ESSENTIAL COMPONENTS INCLUDED Drawing Release Record 1. 4-18-77 ECR-1082 2. 12-27-77 ECR-1082 3. 11-27-77 ECR-1082 4. 12-27-77 ECR-1082 5. 12-27-77 ECR-1082 6. 12-27-77 ECR-1082 7. 12-27-77 ECR-1082 8. 12-27-77 ECR-1082		TERA APERTURE CARD GENERAL ARRANGEMENT SECTIONS F-F & G-G WM. H. ZIMMER NUCLEAR POWER STATION UNIT 1 THE CINCINNATI GAS & ELECTRIC COMPANY COLUMBUS & SOUTHERN OHIO ELECTRIC COMPANY THE DAYTON POWER AND LIGHT COMPANY
SCALE 1/8"=1'-0" DRAWN J. SISON CHECKED J. A. LUNDY ENGINEER J. A. LUNDY DATE 11-30-77 JOB NO. 4130	SARGENT & LUNDY CHICAGO, ILL. DRAWING NO. M-11 M-11

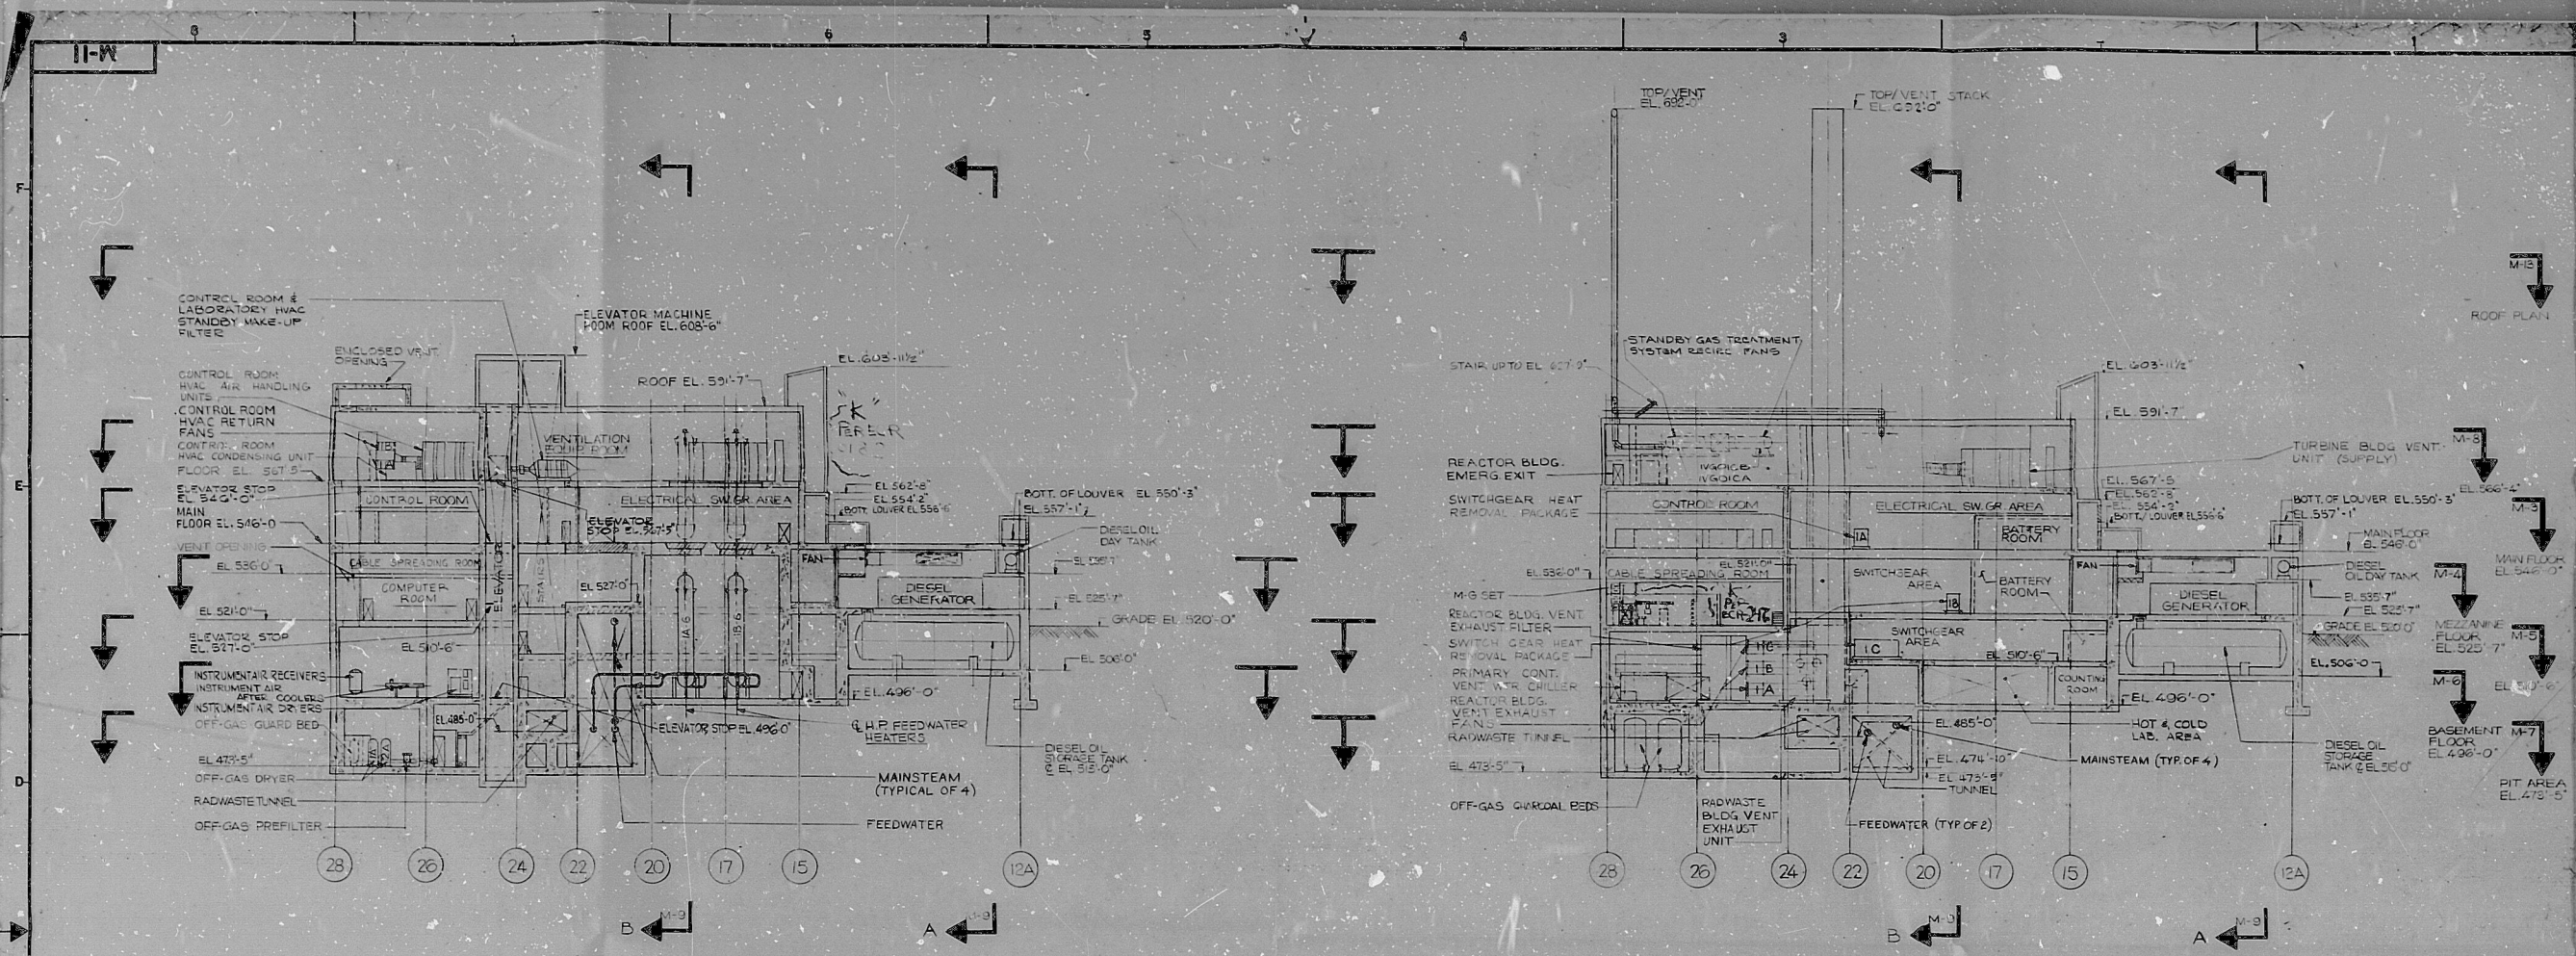
Rev. "K"
 REV. AREA 2 E/B PER ECR-247
 2. ADDED AIR INTAKE ENCLOSURE
 ROOF @ E/7 PER ECR-1082.
 FOR FILE RECORD RELEASE
 PER MT-3891.
